Caution!

Kawasaki Ultra 150 & STXR Owners:

Failure to follow oil line routing will cause major engine damage.

Oil Pump

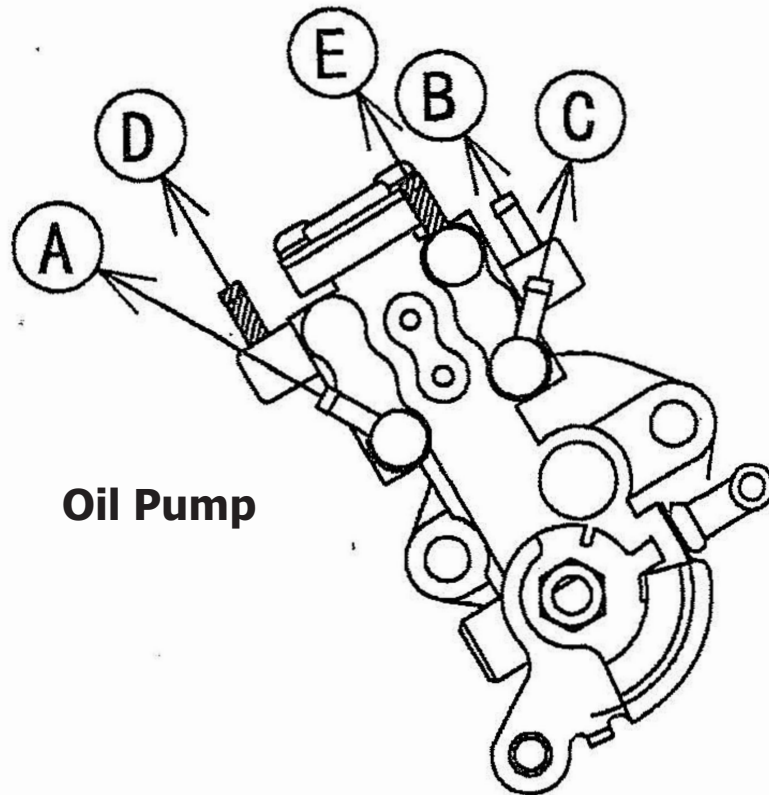
Engine NO.: JHT20AE 000001 - 001172

- A. Carb - Front of ski ~ 2.66 MI
- B. Carb - Middle of ski ~ 4.00 MI
- C. Carb - Rear of ski ~ 2.66 MI
- D. Front Balancer ~ 1.33 MI
- E. Rear Balancer ~ 1.33MI

Engine N O.: JHT20AE001173~

- A. Carb - Front of ski ~ 3.83 MI
- B. Carb - Middle of ski ~ 4.00 MI
- C. Carb - Rear of ski ~ 3.83 MI
- D. Front Balancer ~ 1.33 MI
- E. Rear Balancer ~ 1.33 MI
